Addendum #2
Avon-Washington Township Public Library
Addition and Furniture Project

Date: July 30, 2025
Project: Avon-Washington Township Public Library – Addition and Furniture Project
Project #: 24029
Pages: 16
Bid Dates: **THURSDAY, August 14, 2025 at 2:00 pm (prevailing local time)**

Sheet G0-2 Life Safety Plan

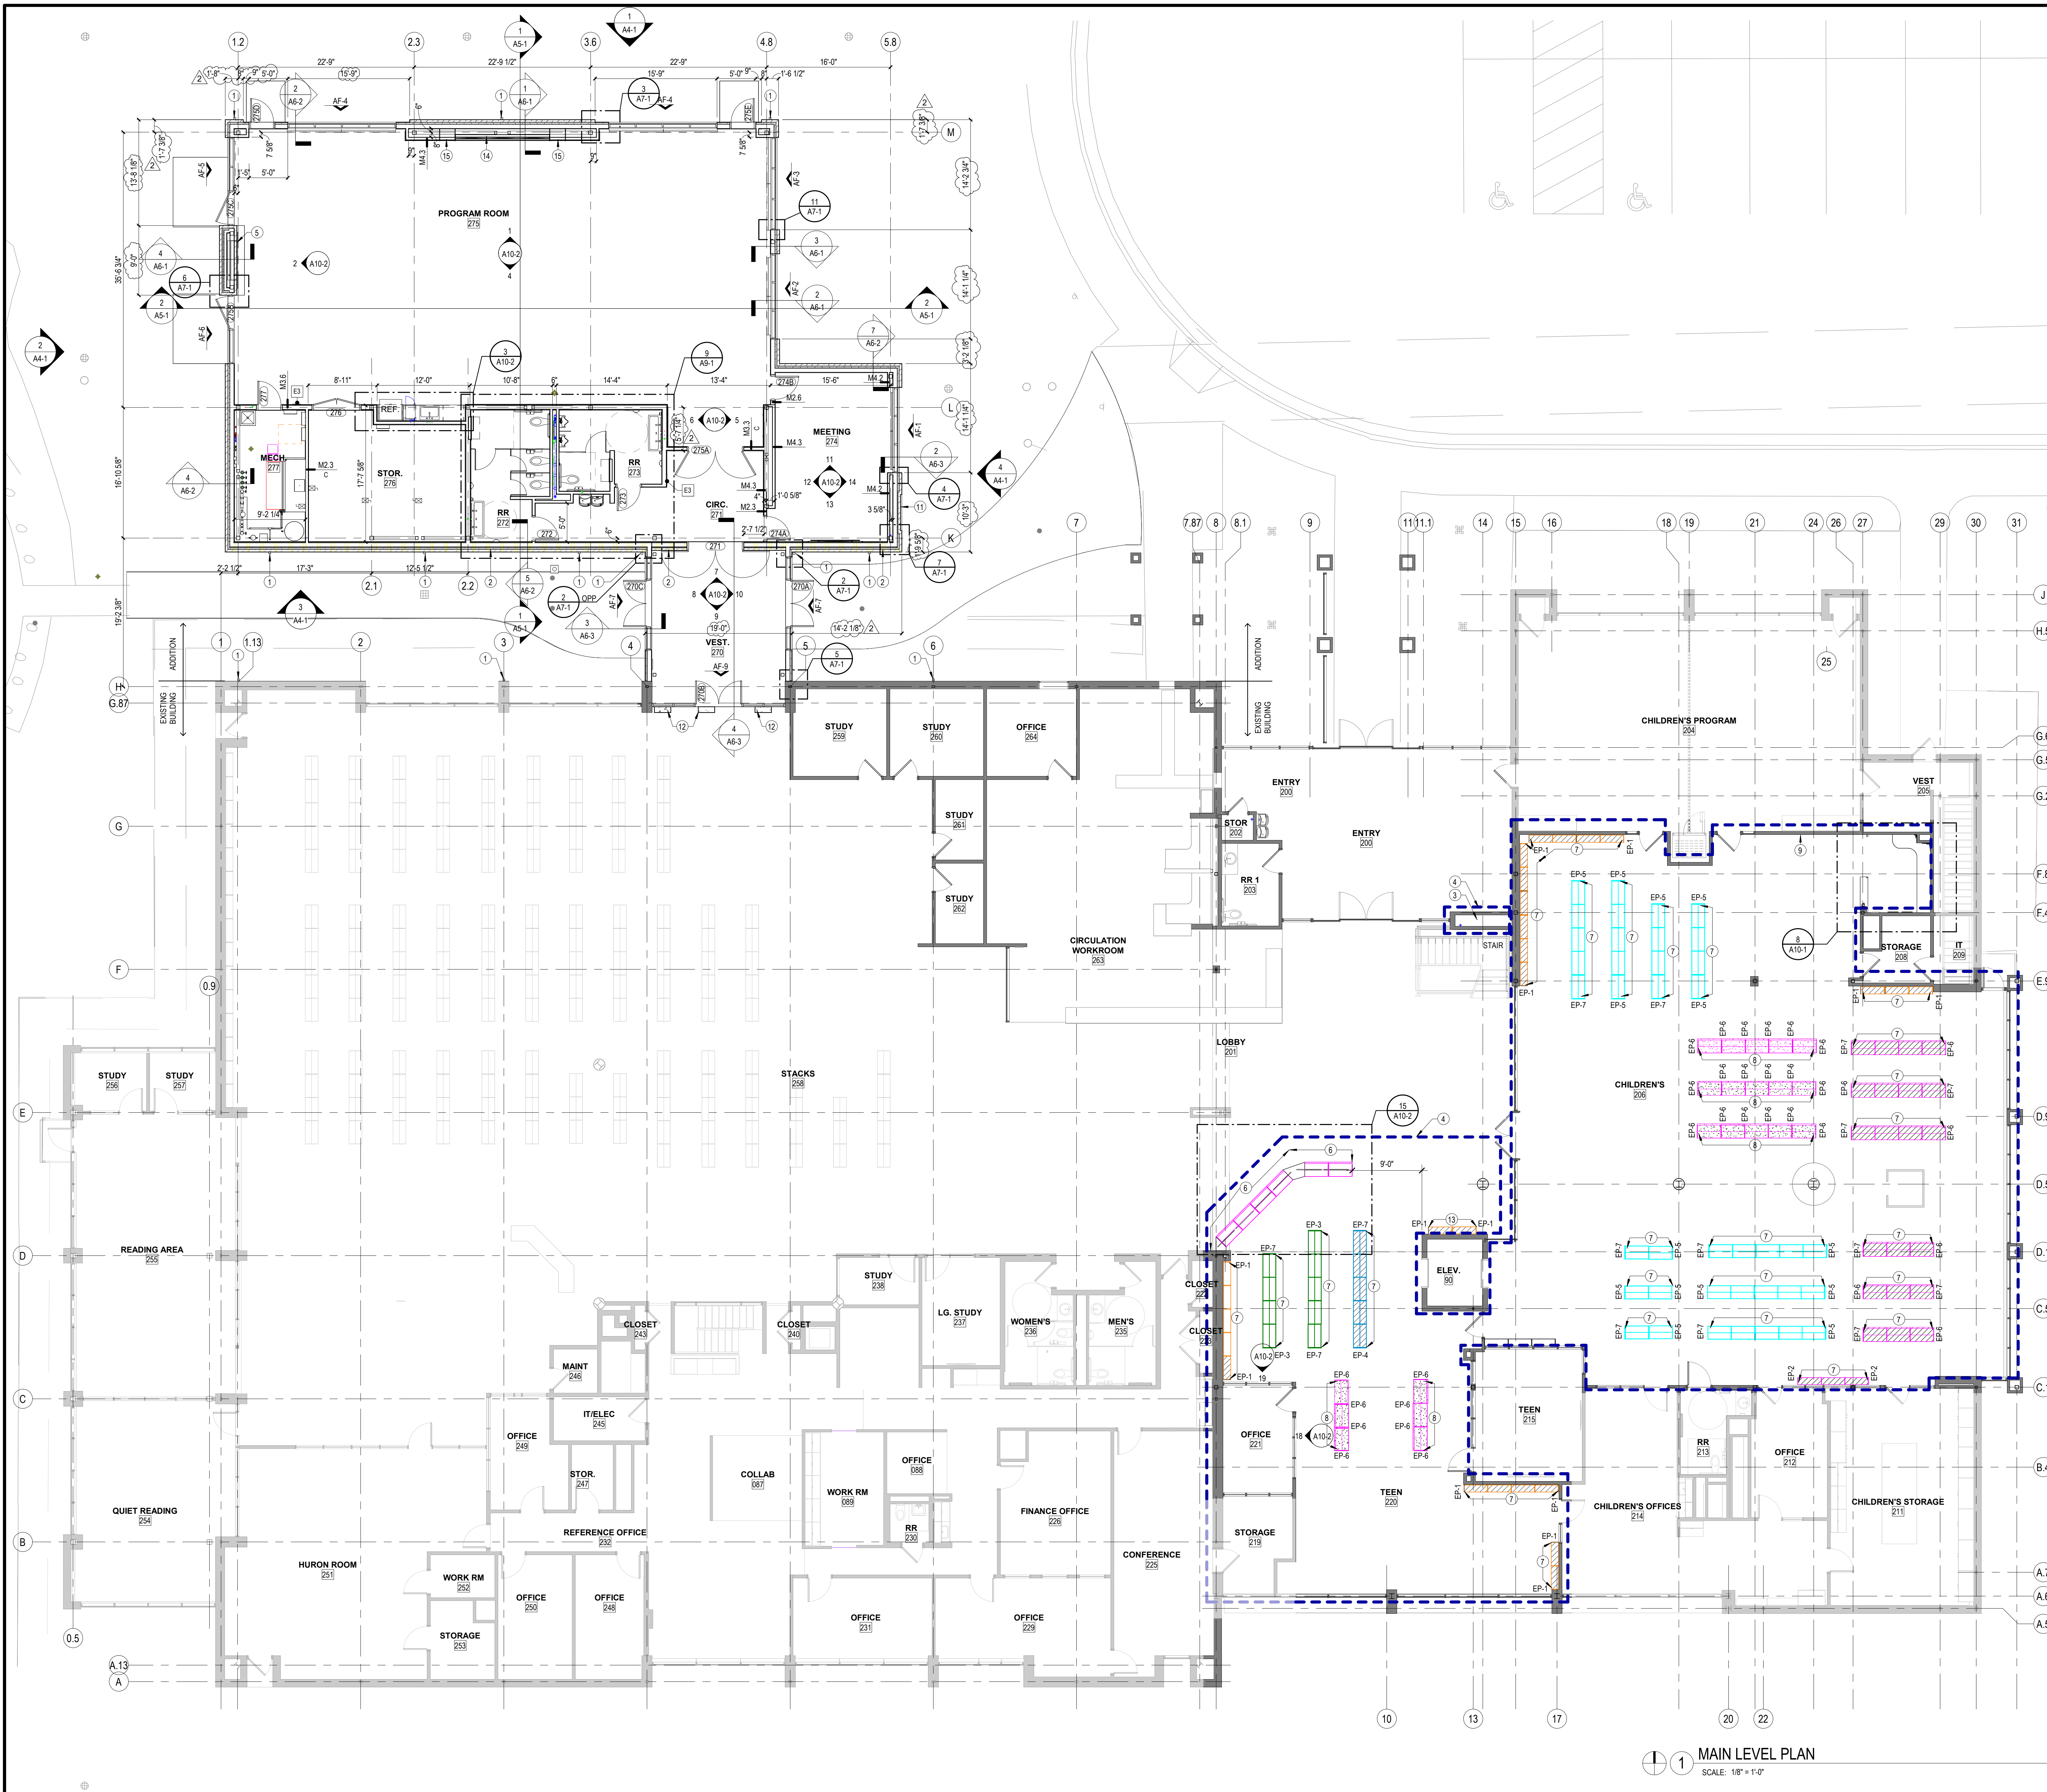
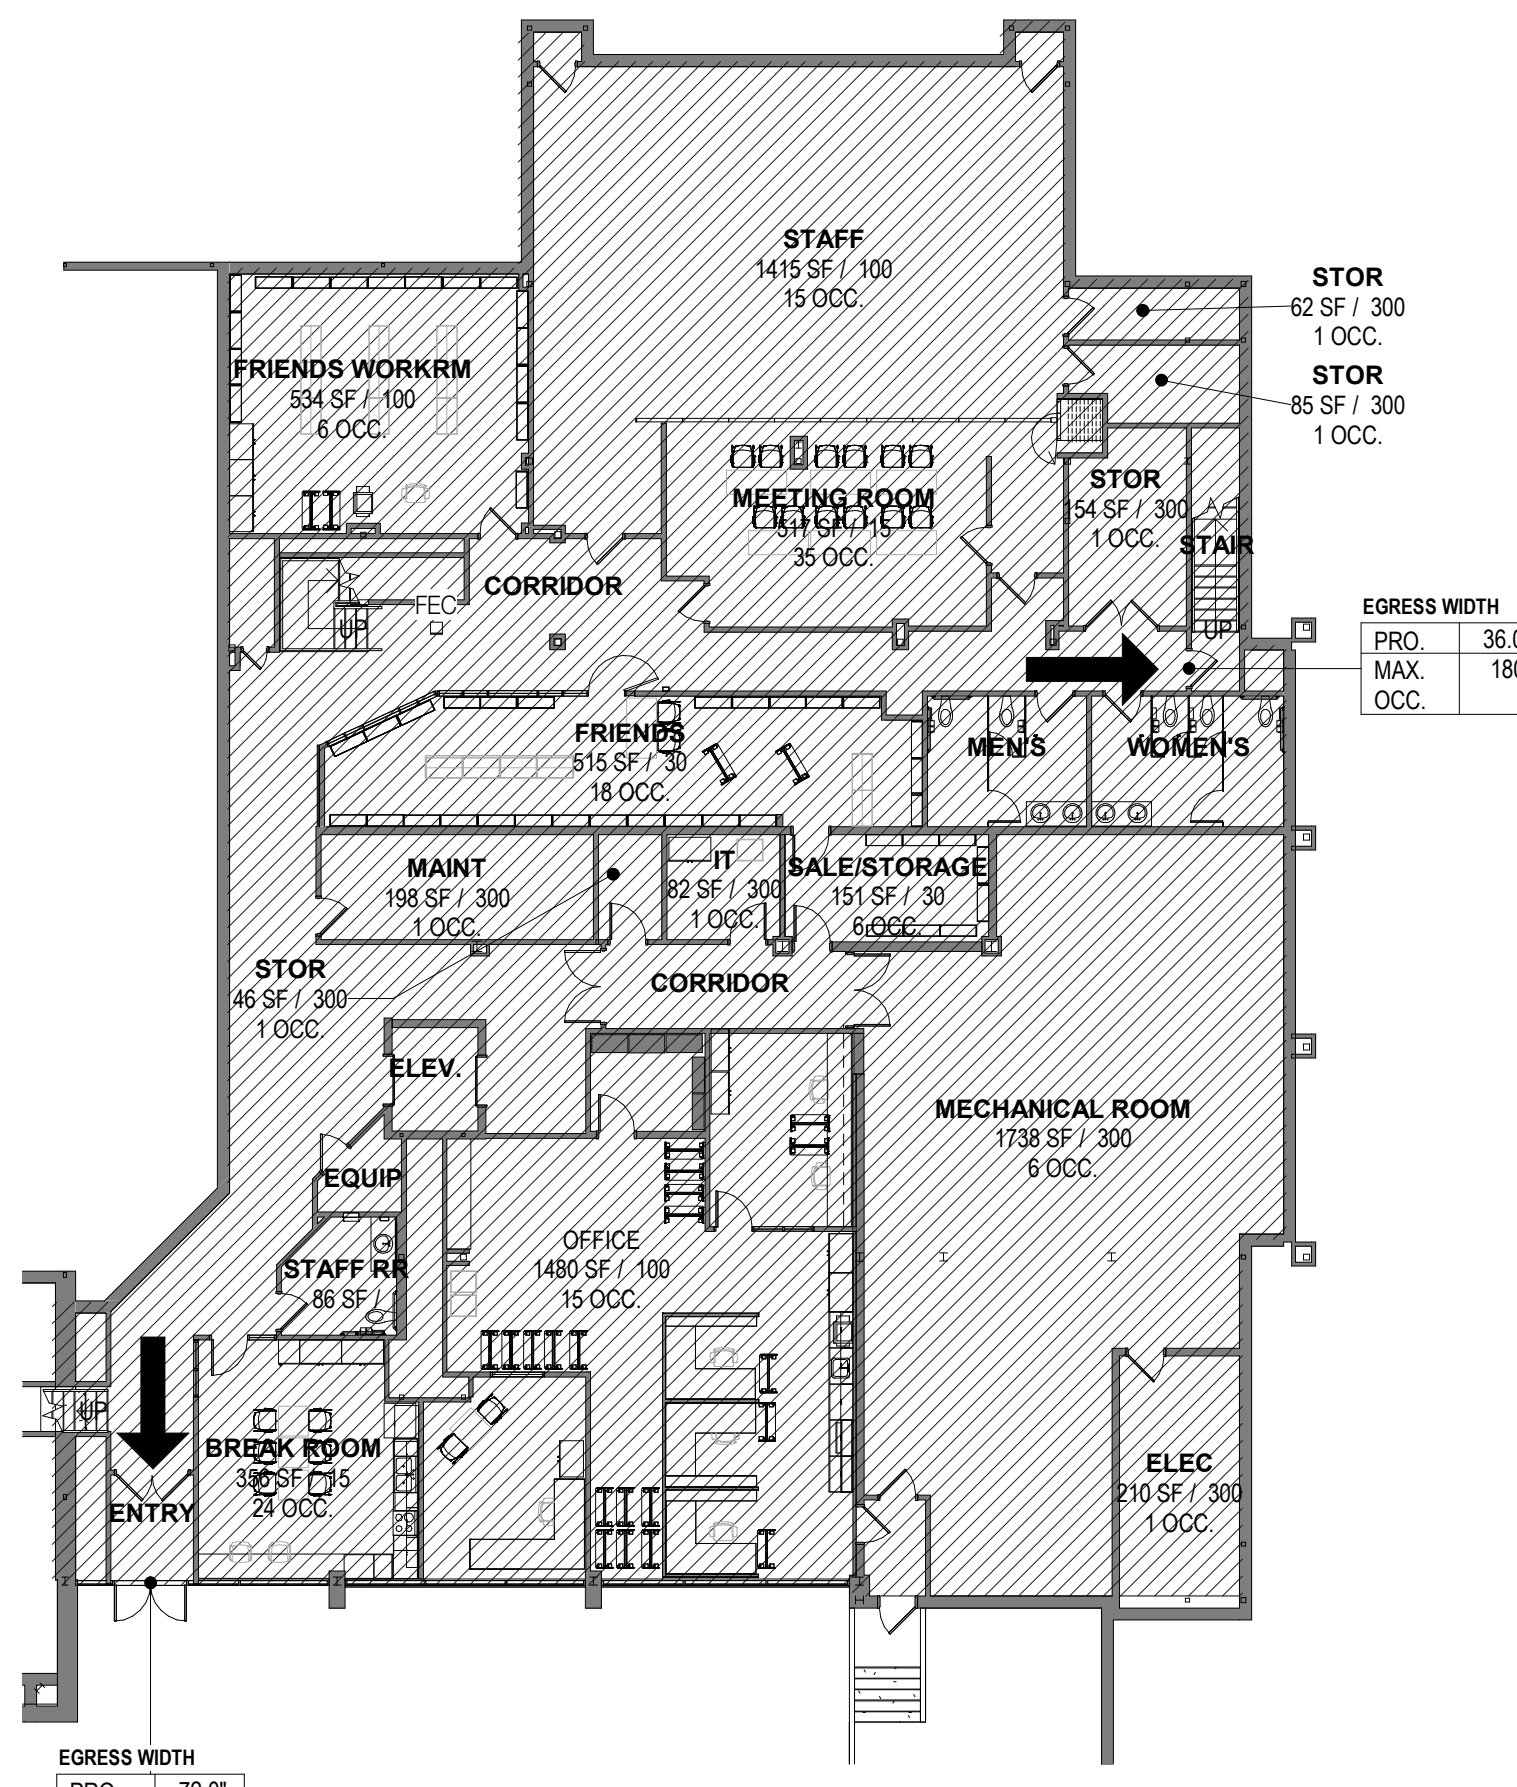
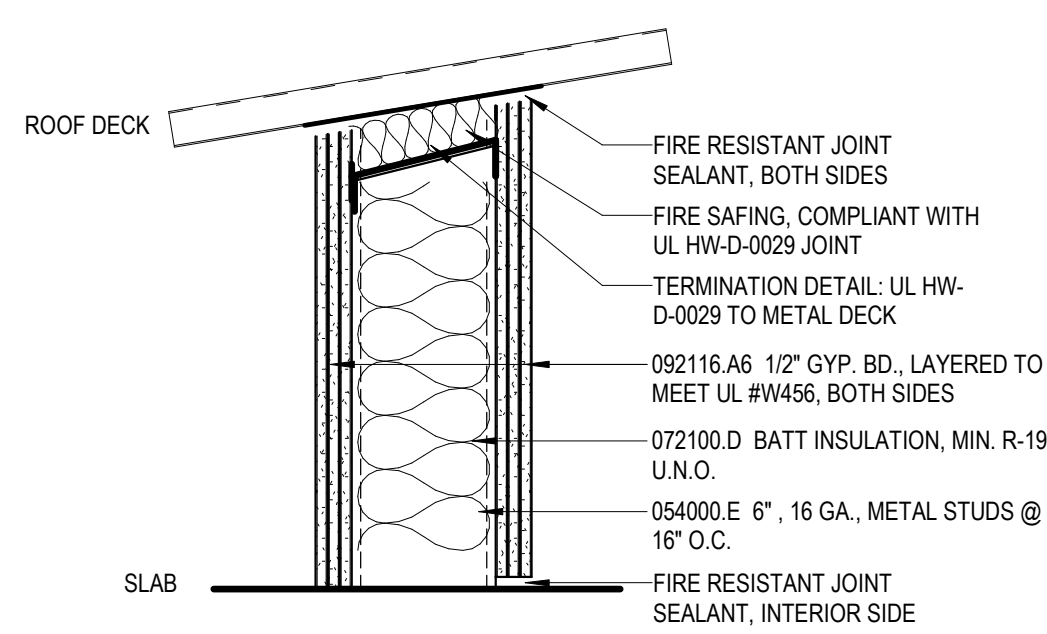
1. REISSUE sheet in its entirety to clarify graphics, add plumbing schedule, and revise Code Review.
2. CLARIFY: there is no sprinkler scope in the addition. A reference to sprinkler work in the Code Review was in regard to a previous variance, and has been reworded for clarity.

SHELVING LEGEND

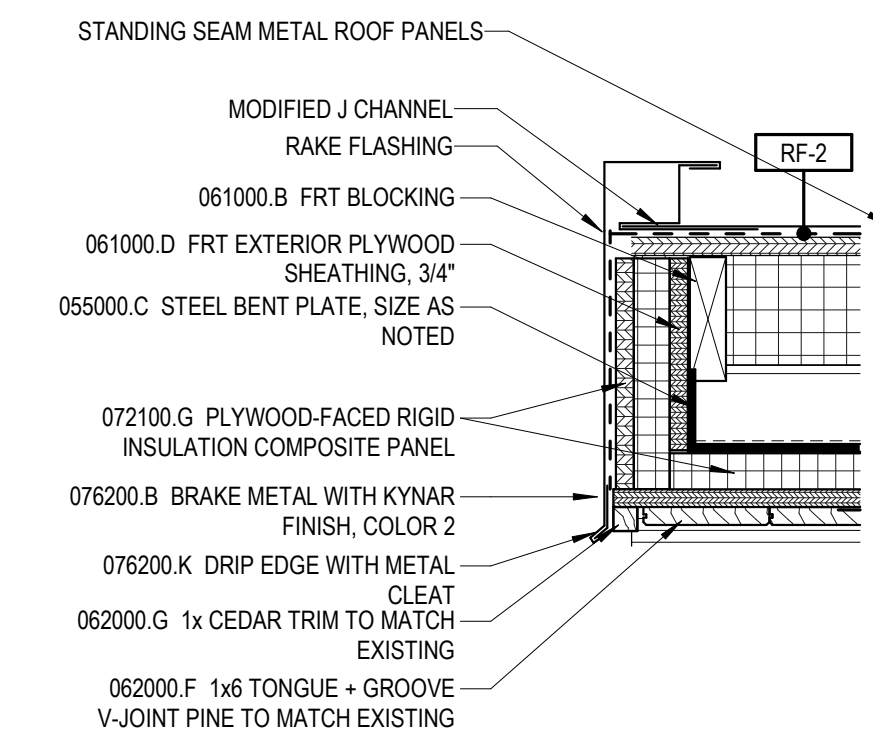
1. ADD missing dimensions to floor plan as shown in the attached reissued sheet.
2. ADD general note L.
3. CLARIFY notes on Shelving Legend, metal library shelving is OFOI.
